UNITED STATES PATENT AND TRADEMARK OFFICE

APPLICATION NO.	FILING DATE	FIRST NAMED INVENTOR	ATTORNEY DOCKET NO.	CONFIRMATION NO.
10/644,372	08/20/2003	Patrick H. Buffet	RPS920030106US1	6420
47052	7590	11/17/2004	EXAMINER	
SAWYER LAW GROUP LLP			THAI, LUAN C	
PO BOX 51418			ART UNIT	
PALO ALTO, CA 94303			PAPER NUMBER	
			2829

Office Action Summary

DETAILED ACTION

FIG. 1

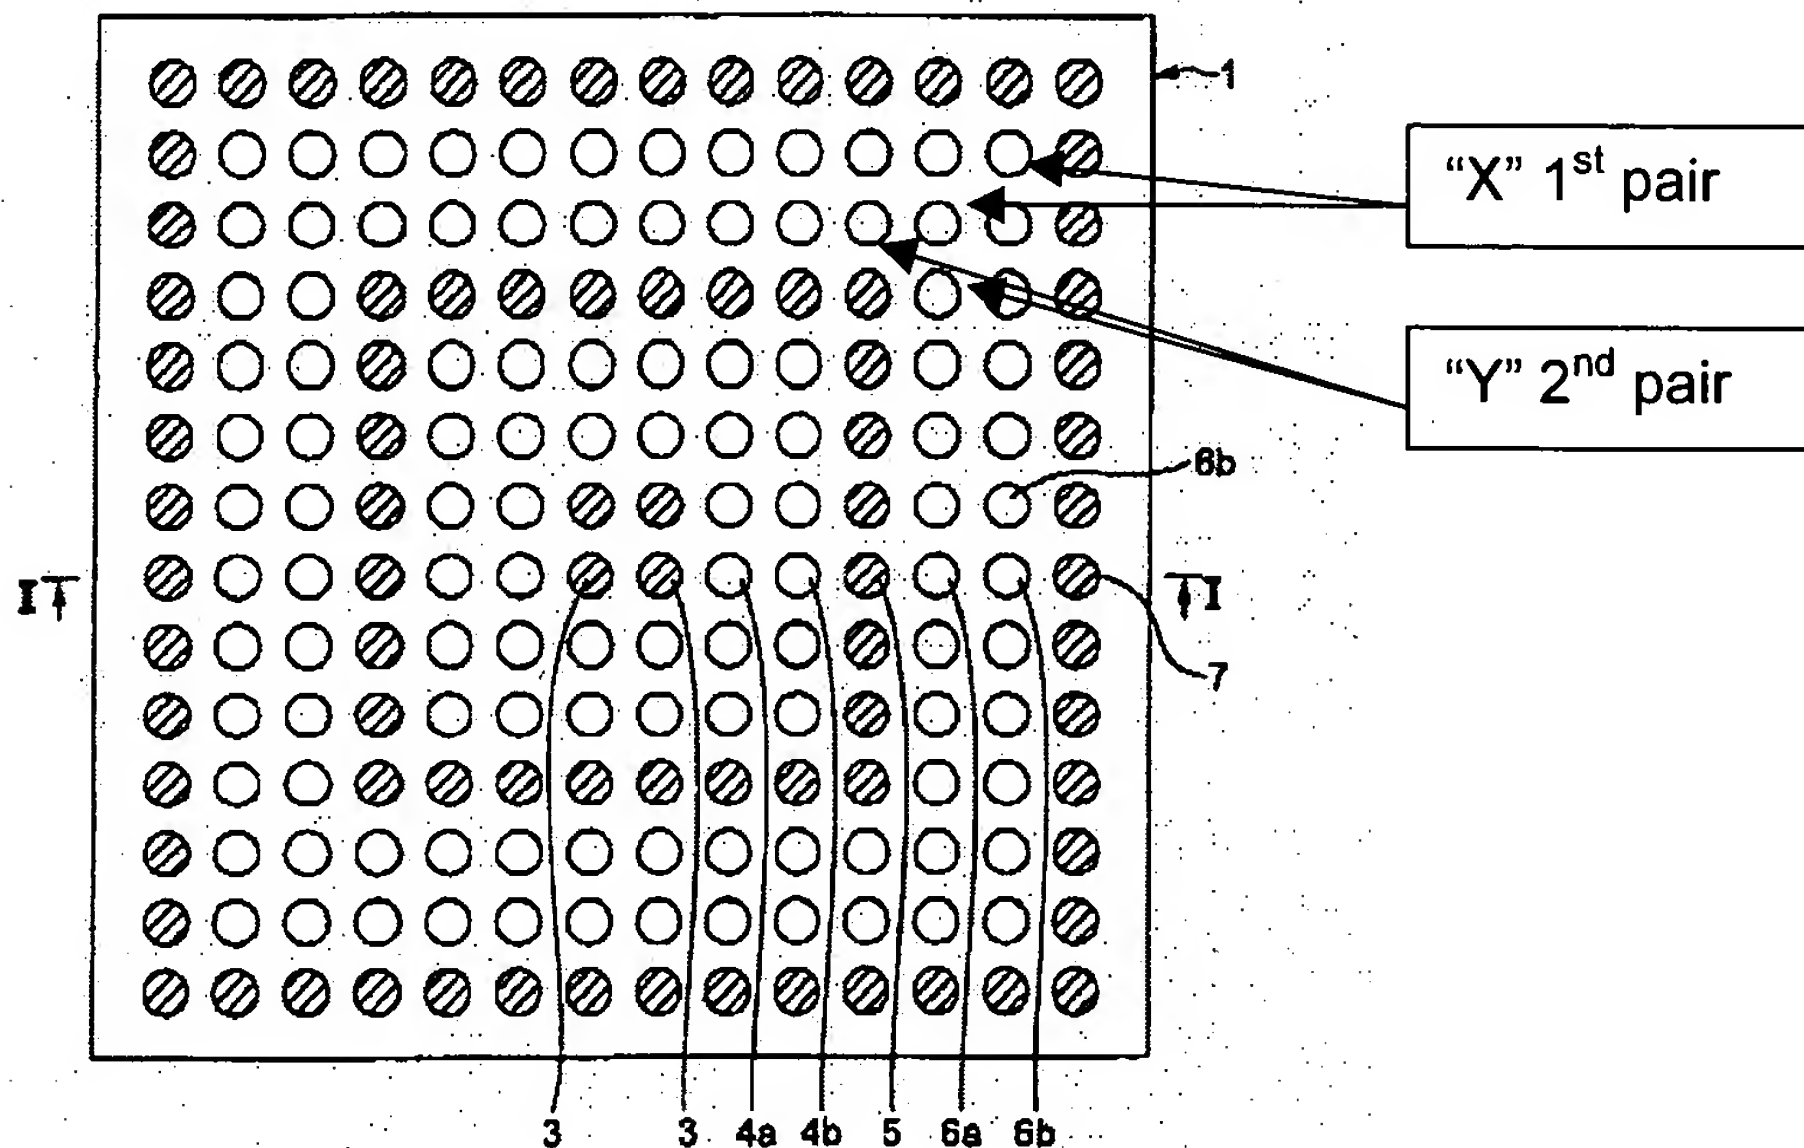
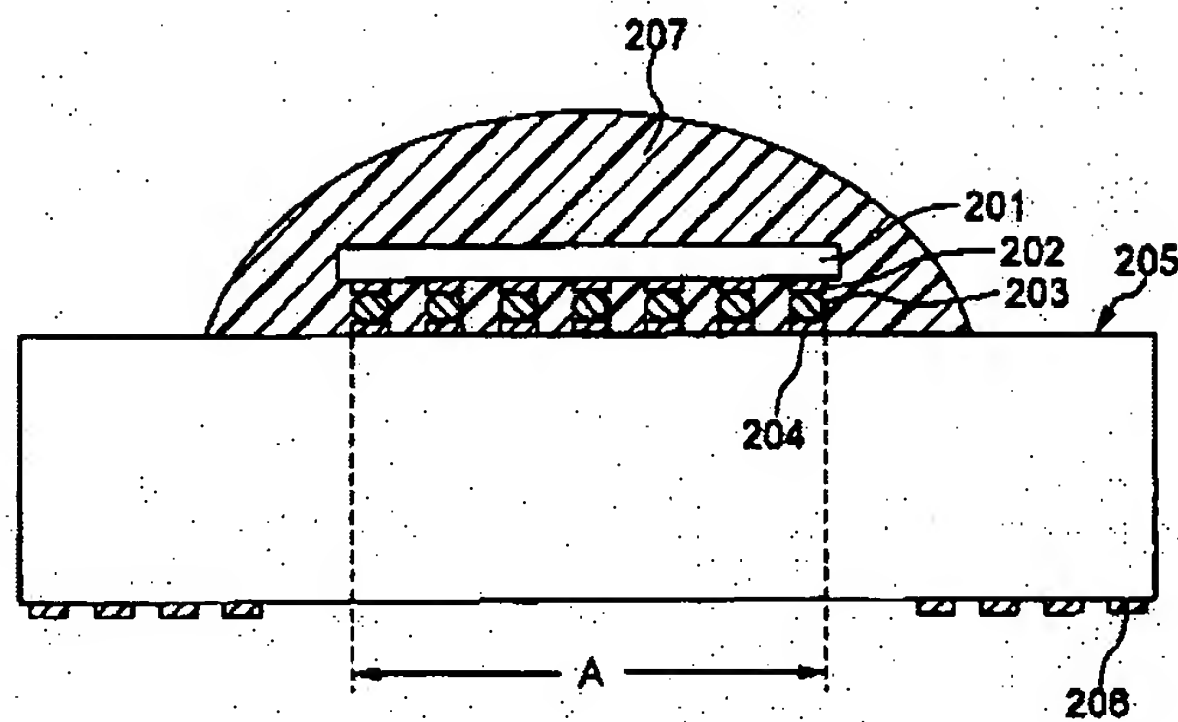
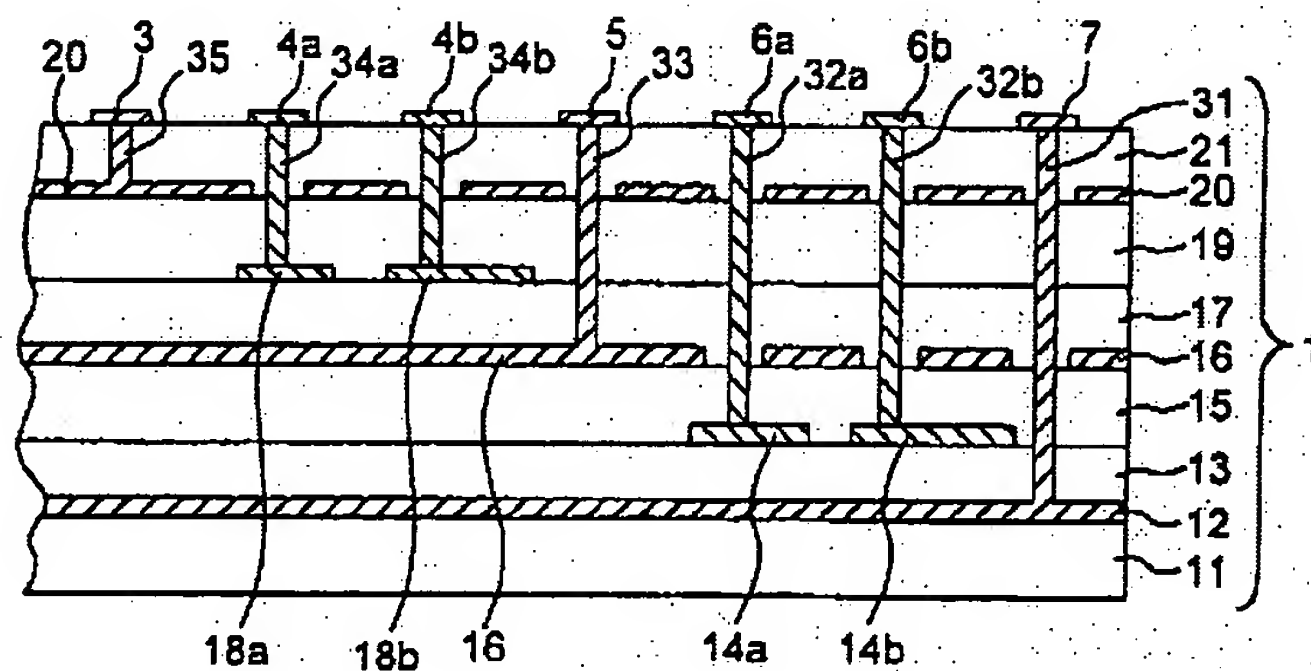
Regarding claims 1, 4-7 and 11-17, Arima et al (see specifically figures 1-2 and 17A attached) disclose a multi-layer semiconductor chip package, comprising:

a first pair of conductors (X) for carrying a first signal in a layer of a carrier (205 of figure 17A) having a similar terminals arrangement as shown in figure 1 (Col. 8, lines 8-50); a second pair (Y) of conductors for carrying a second signal adjacent to the first pair of conductors in the layer, wherein the second pairs of conductors (Y) is positioned to be orthogonal to the first pair of conductors (X) and equidistant to each conductor in the first pair of conductors (X) and wherein the layer is near an interface between the carrier and a chip (see figure 17A). By forming the package as described above, even if signal wiring

**FIG. 2**

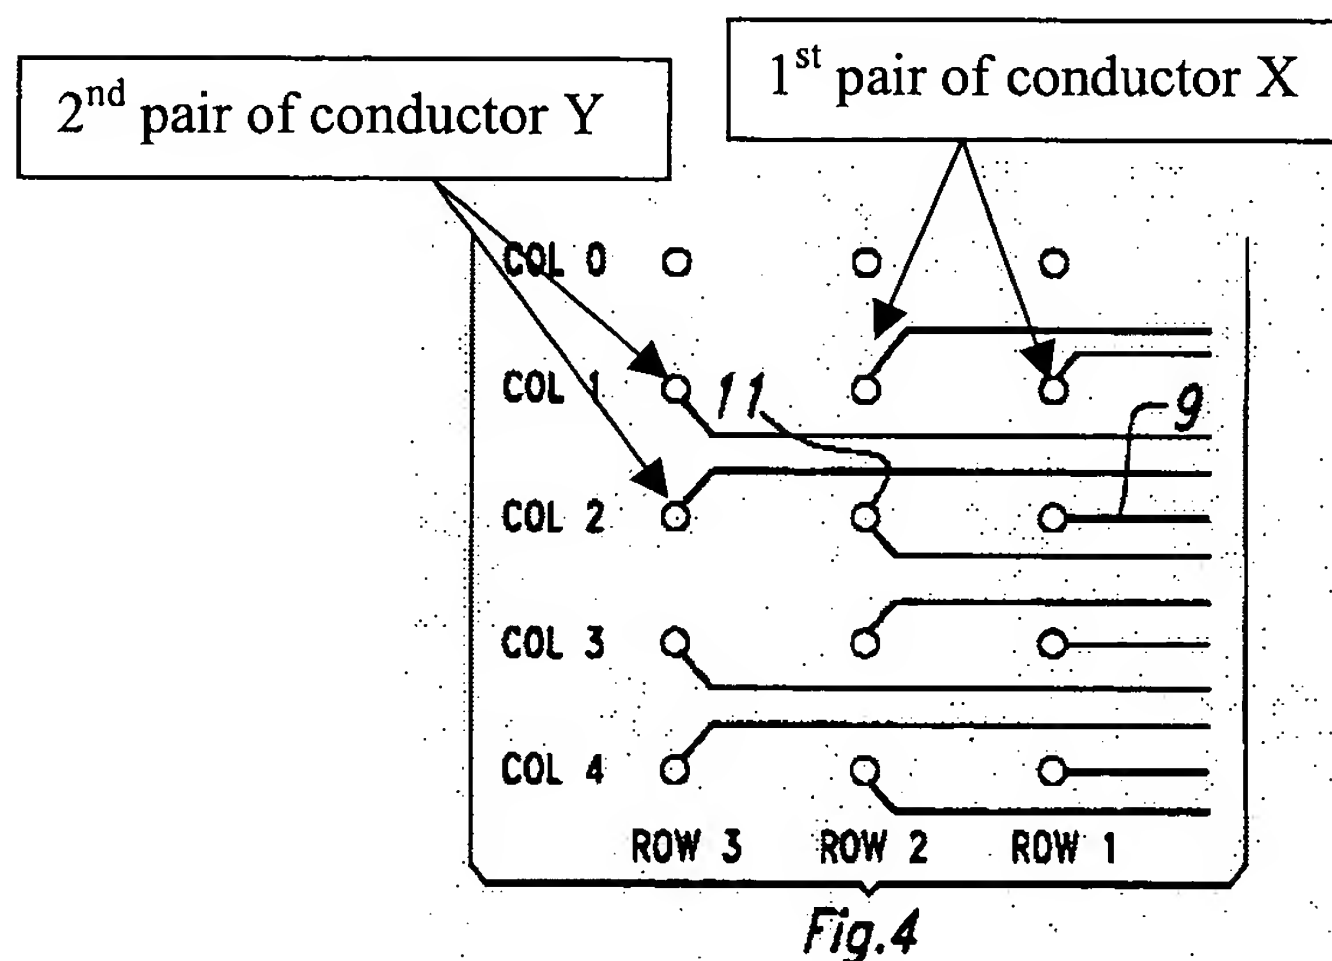
Regarding claims 2, 8, 10 and 19, Arima et al further teach a height (e.g., 34a-34b in figure 2) of the 1st pair "X" being substantially shorter than a height (e.g., 32a-32b in figure 2) of the 2nd pair "Y".

FIG. 10

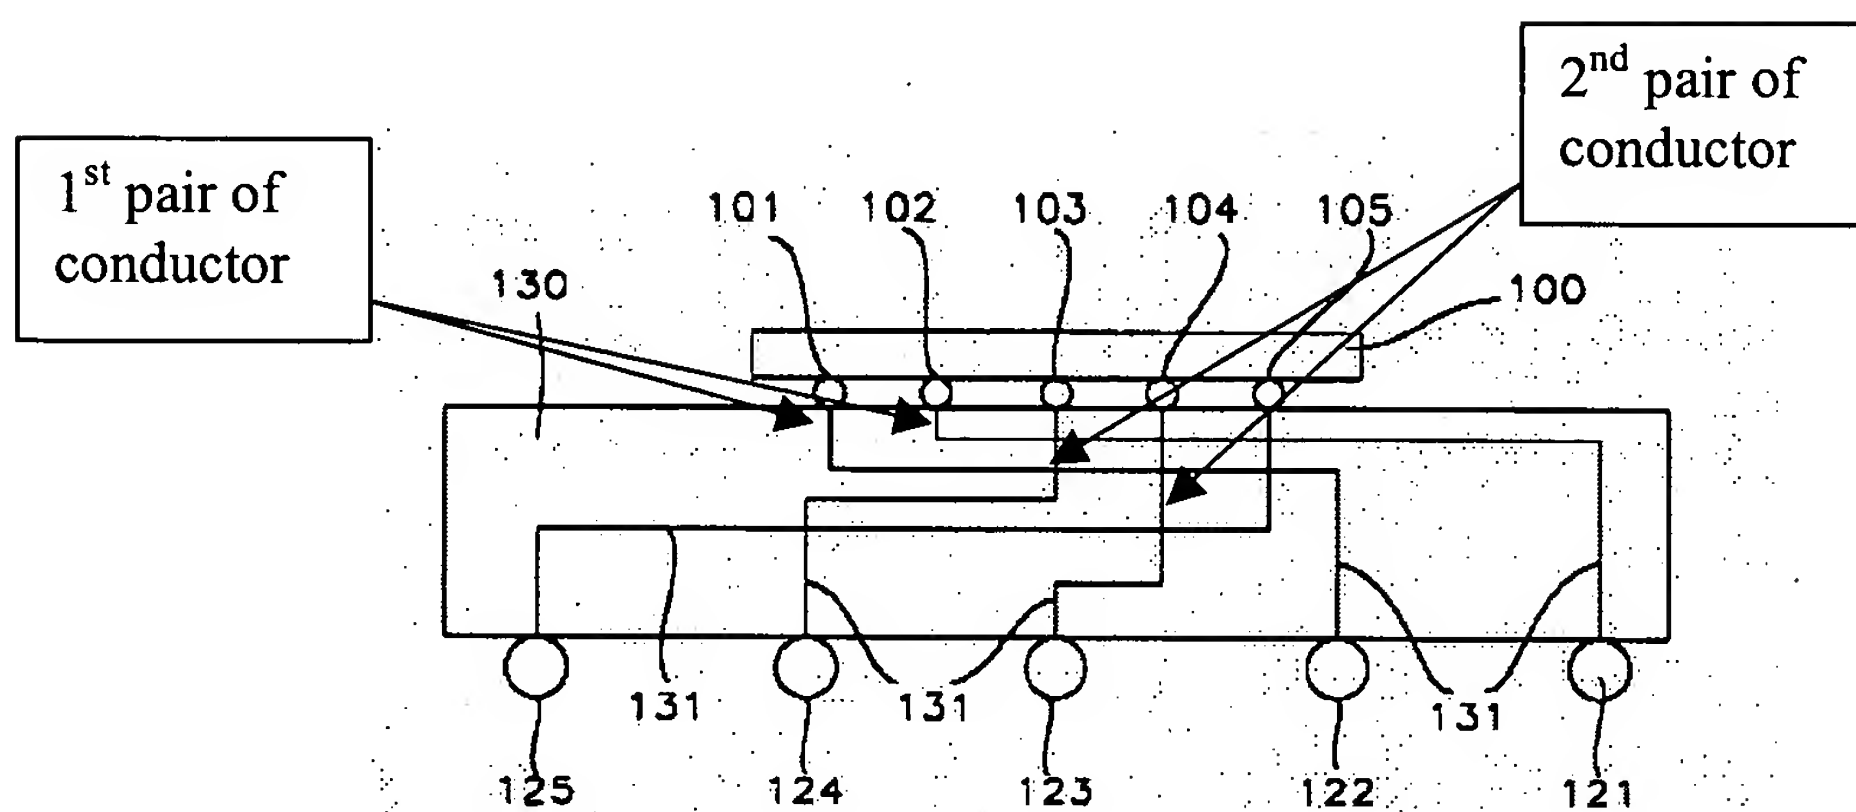
Regarding claims 1-3, 7-11, and 14-16, Lin discloses (see specifically figures 10) a multi-layer semiconductor chip package, comprising: a first pair of conductors, which are the vertical wirings 131 connected to bumps 101-102, for carrying a first signal in a layer of a carrier (130) of the package, wherein the layer is near an interface between the

signal adjacent to the first pair of conductors in the layer, wherein a height of the first pair of conductors (e.g., the vertical wirings 131 connected to bumps 101-102) is substantially shorter than a height of the second pair of conductors (e.g., the vertical wirings 131 connected to bumps 103-104), and wherein the height of the second pair of conductors in a subsequent layer (e.g., the vertical wiring 131 connected to contact points 123-124) of the carrier is shorter than the height of the first pair of conductors in the subsequent layer (e.g., the vertical wiring 131 connected to contact points 121-122). Thus, all the claimed structure of the invention has been taught. Lin does not explicitly disclose cross-talk between the first and second pairs of conductors being substantially minimized.

Since applicant's claimed structures in claims 1-3, 7-11, 14-16, 18-21 and 24 do not distinguish over the Lin reference, the claimed of "cross-talk being substantially minimized" could have been included in Lin's structure.
